Joint Witness Statement Stormwater management

Ashbourne [FTAA-2507-1087]
11 December 2025

- d. *Advice to MPDC concludes (Memorandum 2) that “the information provided to date has not demonstrated that the abnormal groundwater conditions at the Ashbourne site have been adequately allowed for within the proposed design”.*

Figure 1: Updated Monitored Groundwater Levels.

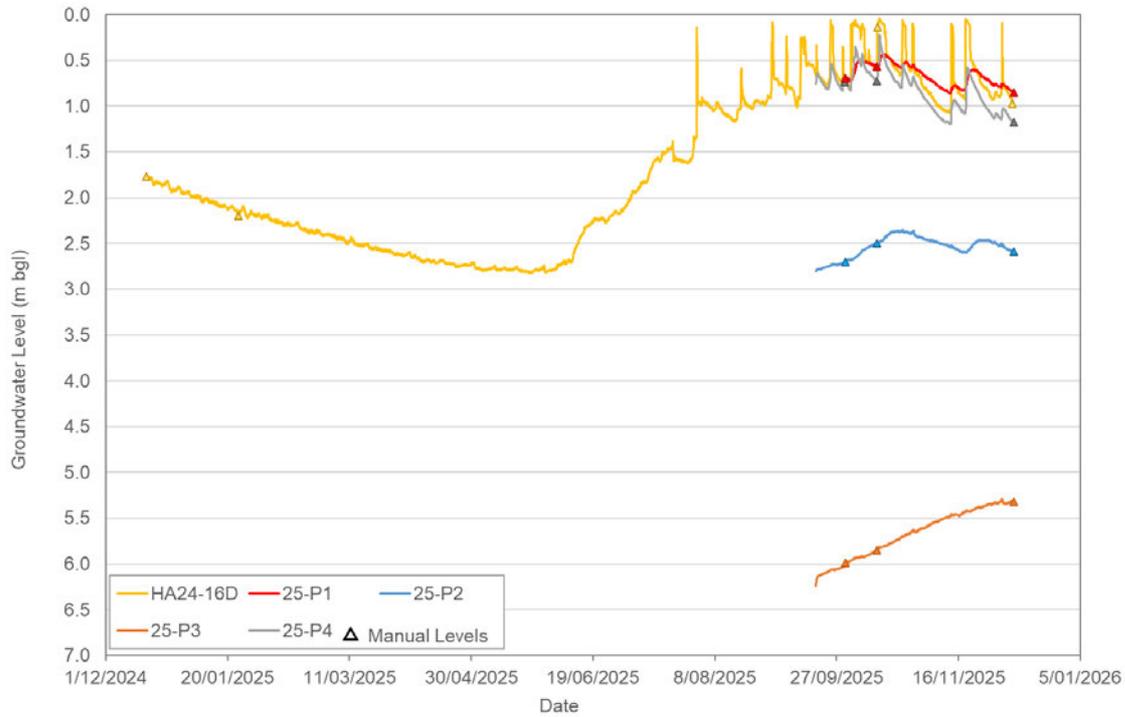
- Groundwater levels are shallow in some periods of the year. The latest groundwater levels are presented in Figure 1, it shows 3-months of data for four sites and 1-year of data for one site.

- JW states that whilst the data is useful, it is limited in duration which he considers important for understanding the frequency, duration and intensity that drains will be required to be operational. Jon recommends a longer term synthesised groundwater hydrograph to assist in providing this understanding (added to consent condition points below).

Figure 2: Existing Topography in area of Proposed Retirement Village.

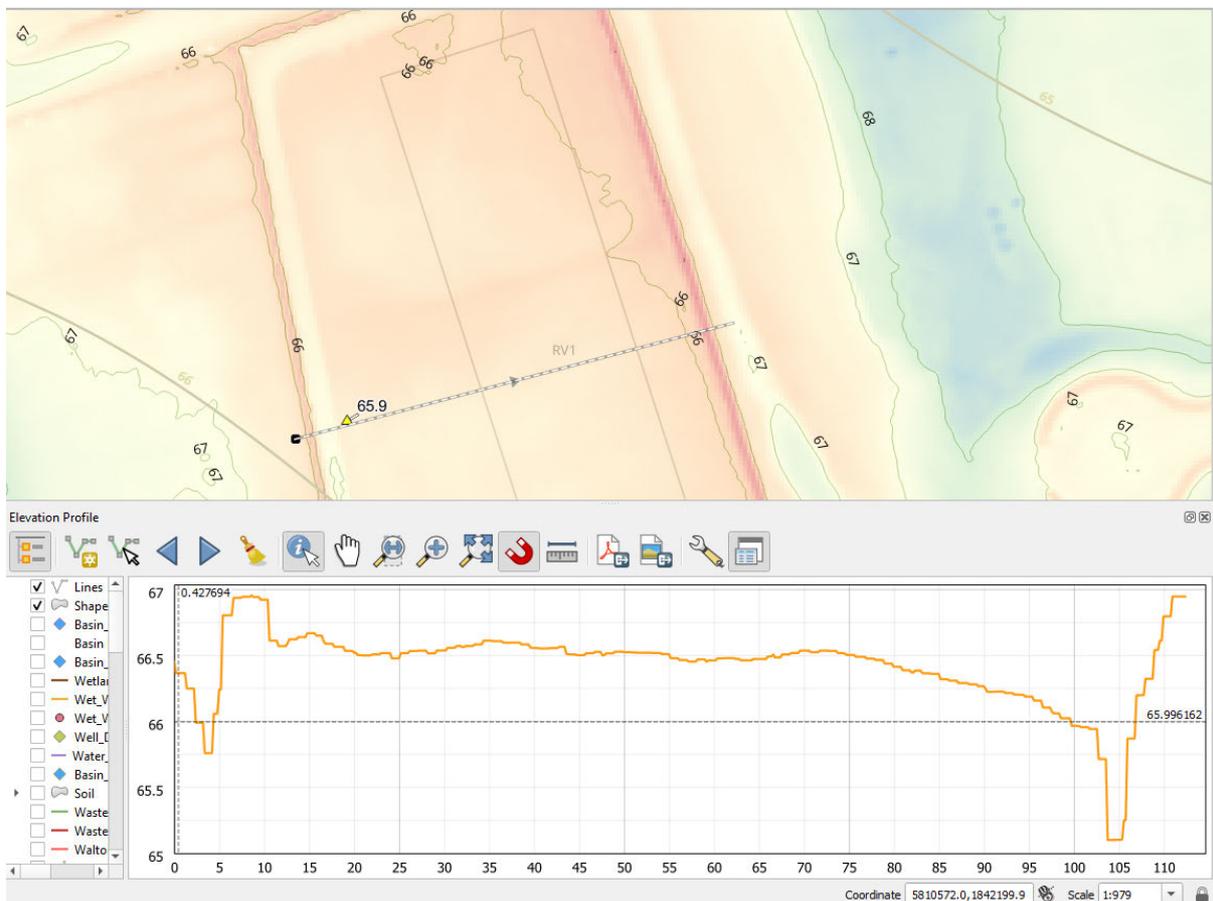
- The existing farm drain network is affecting the current groundwater levels (Figure 2, Figure 3 and Figure 4).
- With the base case hydraulic conductivity and recharge scenario and groundwater levels 0.1 mBGL (i.e. higher than previous modelling), the modelling indicates that groundwater levels between the proposed drains (modelled at 75 m apart) will be approximately 0.5 m below the existing ground level (Figures 5 and 6).
- Additional modelling covers sensitivity analysis on the aquifer parameters, aquifer depth and recharge, as discussed in the following section.
- This sensitivity analysis modelling indicates that under some of the scenarios tested (e.g. low hydraulic conductivity and high recharge scenarios), there is some uncertainty as to whether the 75 m drain spacing is adequate.

Figure 3: Current farm drains with starting GW depth 0.6 m BGL

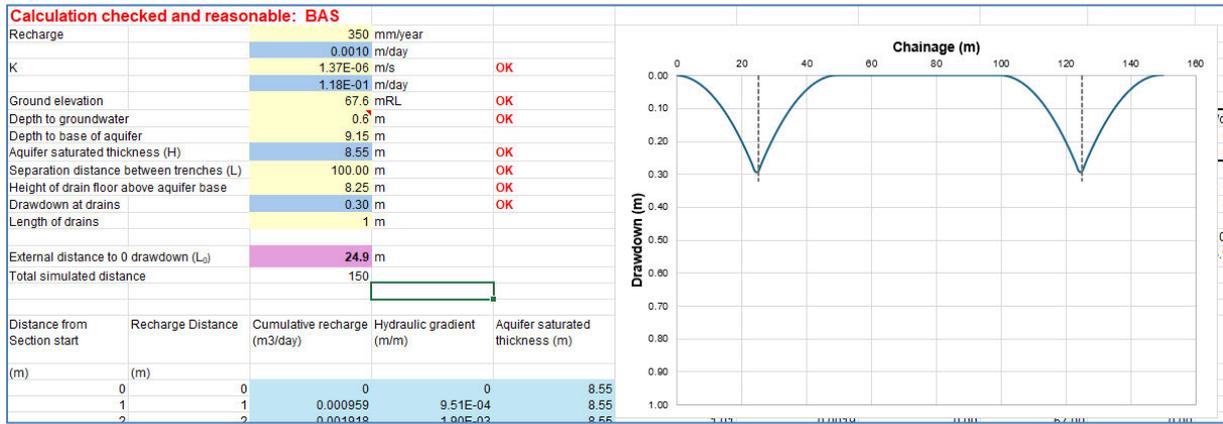
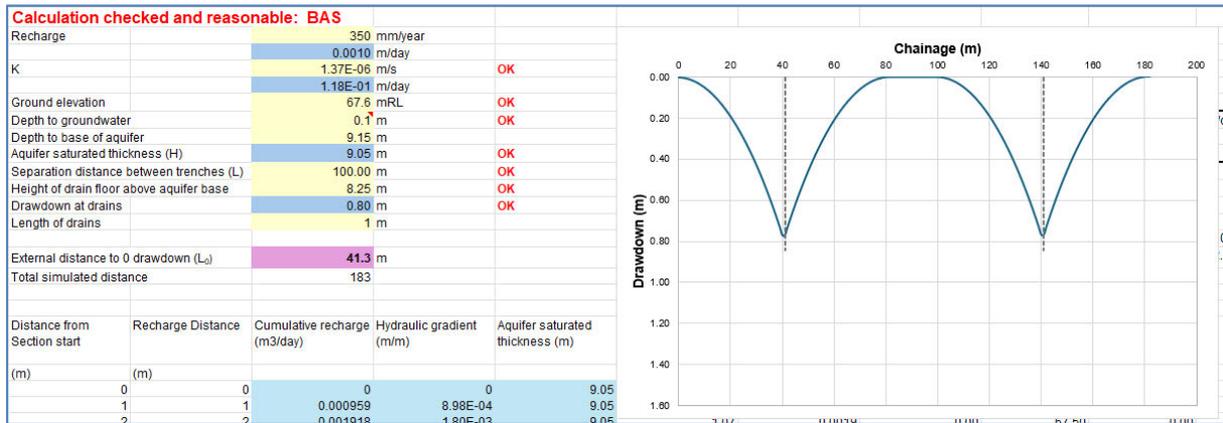
In summary, WGA have carried out modelling with starting groundwater levels at 0.1 m below ground level which is a hypothetical level for the low-lying areas for winter/spring conditions (essentially assumes full saturation). However, these areas are currently suppressed by farm drains to approximately 0.5 m below ground level. It is effectively a naturalised scenario without any drainage. It is a model scenario to check the effectiveness of the drainage system during high groundwater conditions. TC and JW agree that this is useful as a naturalised baseline case.

Sensitivity Analysis for Evaluating Subsoil Drain Design

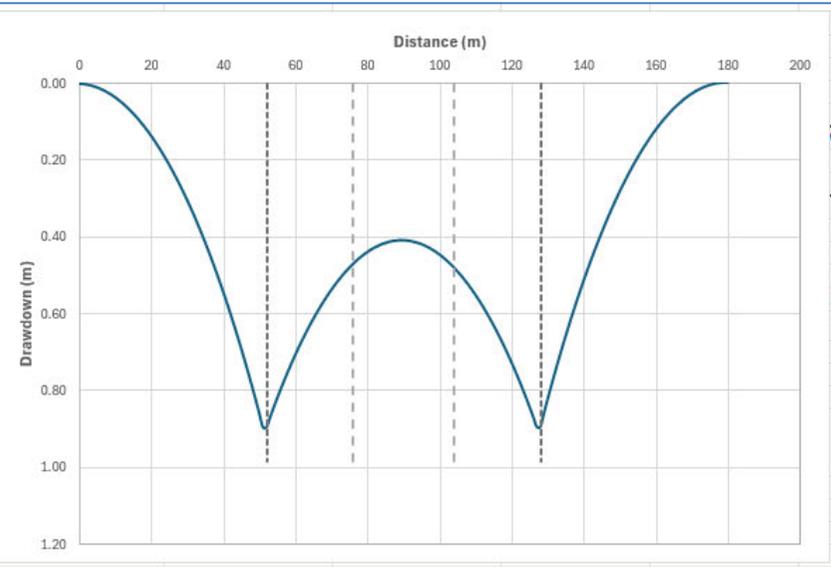
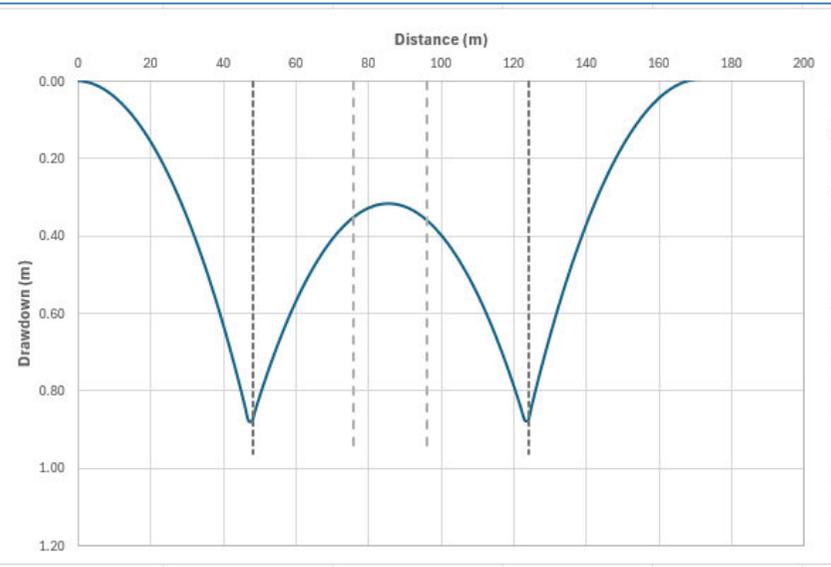
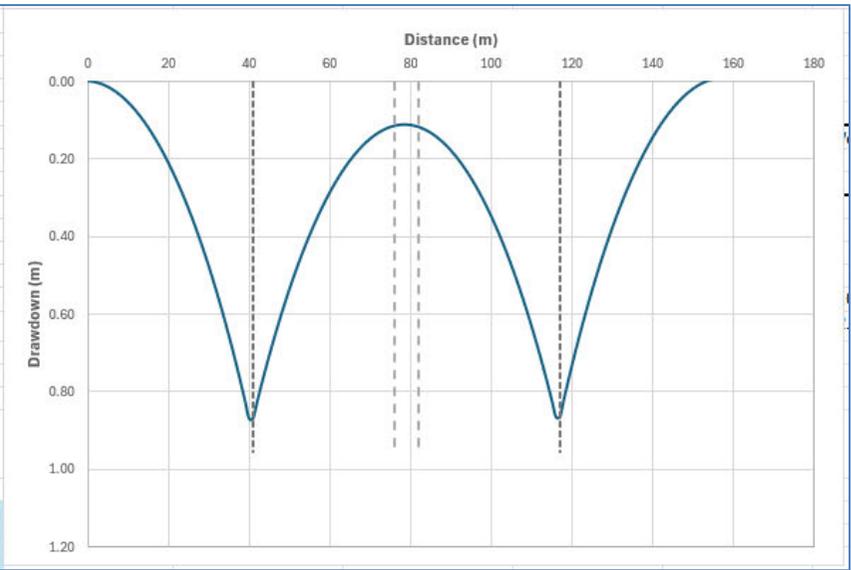
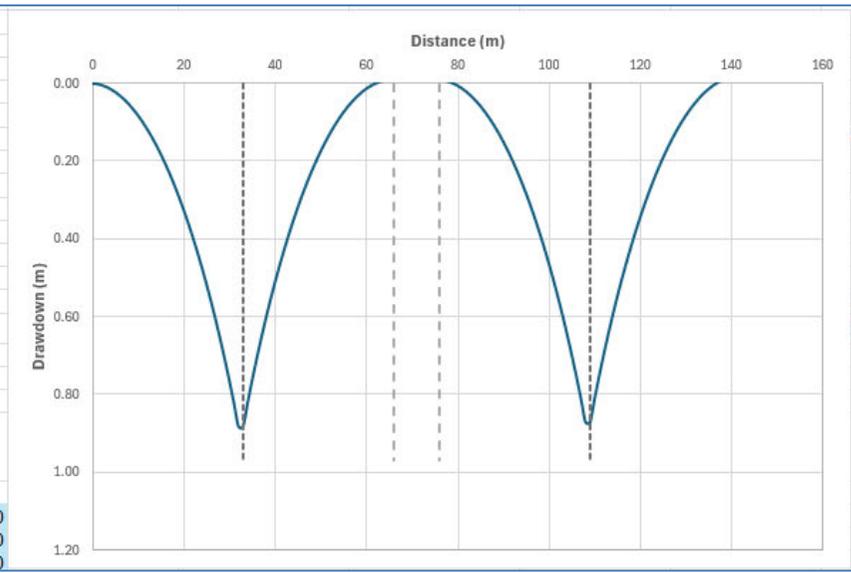
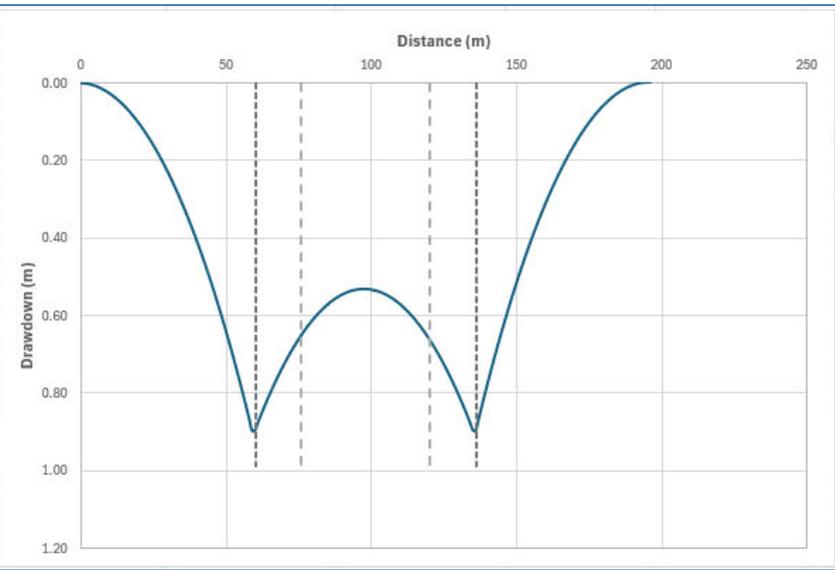
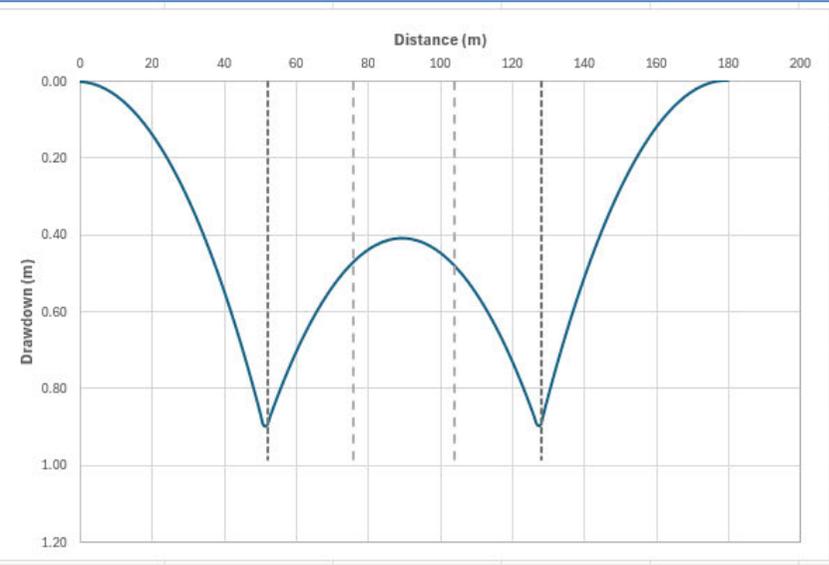
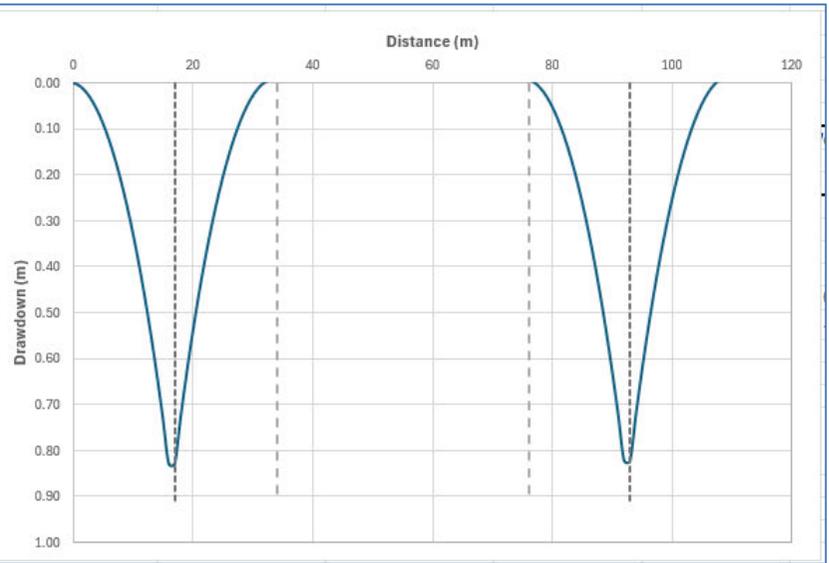
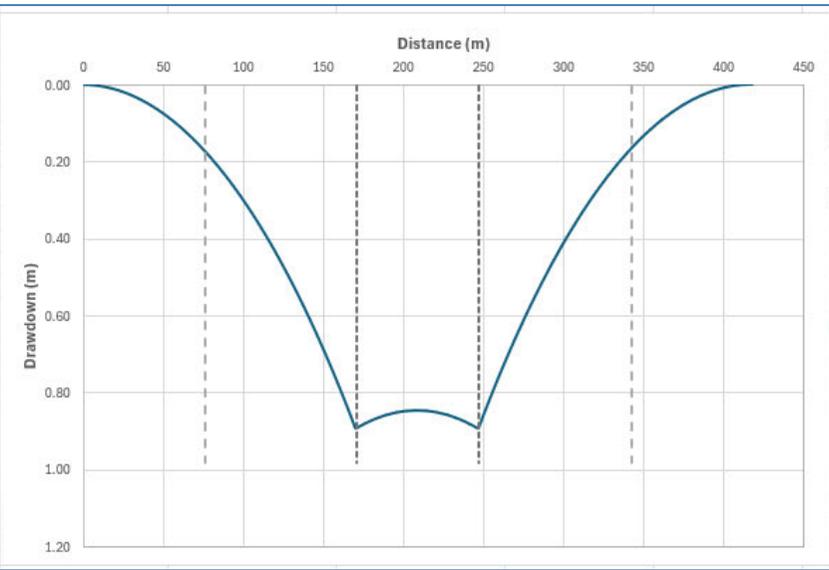
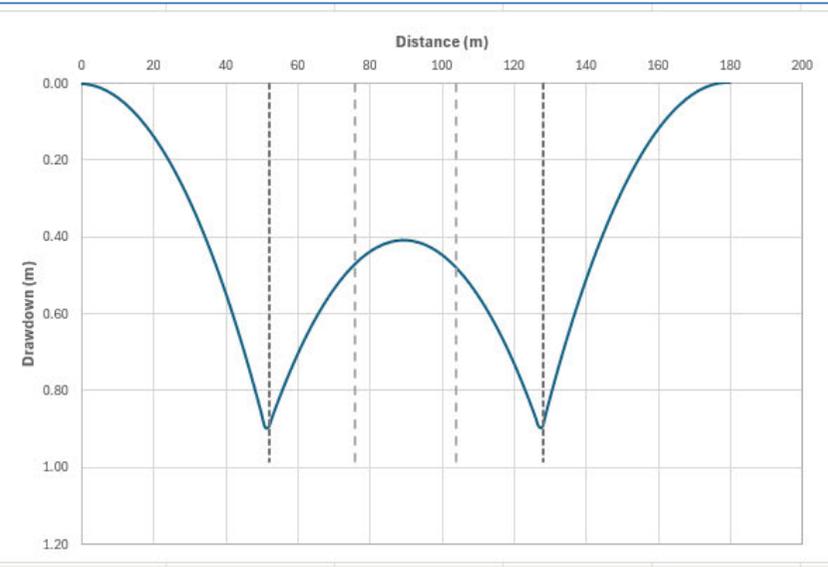
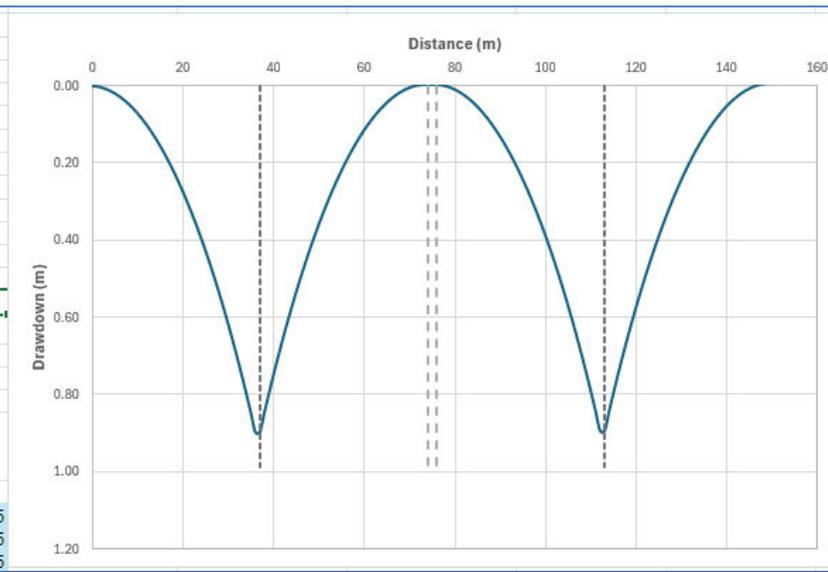
WGA have carried out further sensitivity analysis including aquifer thickness (4 m to 12 m), hydraulic conductivity (1.50E-05 to 1.37E-06 m/s) and recharge (250 mm to 500 mm). The results of the analysis are presented in **Appendix A**. These results indicate detailed design of the subsoil drains will need to be carefully considered where:

- the aquifer is thin (i.e. 4 m to aquitard layer),
- when low hydraulic conductivity layers are encountered (i.e. silt layers), or
- high recharge conditions (high rainfall winter/spring periods).

The results of the sensitivity analysis indicates that further considerations of drain configuration may be required if:

- the localized hydraulic parameters differ from the assumed parameters e.g. hydraulic conductivity and thickness of the Hinuera Formation; and
- the longer term groundwater level and recharge analysis recommended below indicates that higher rates of recharge (than used in the base case analysis) occur during wet periods at this site.
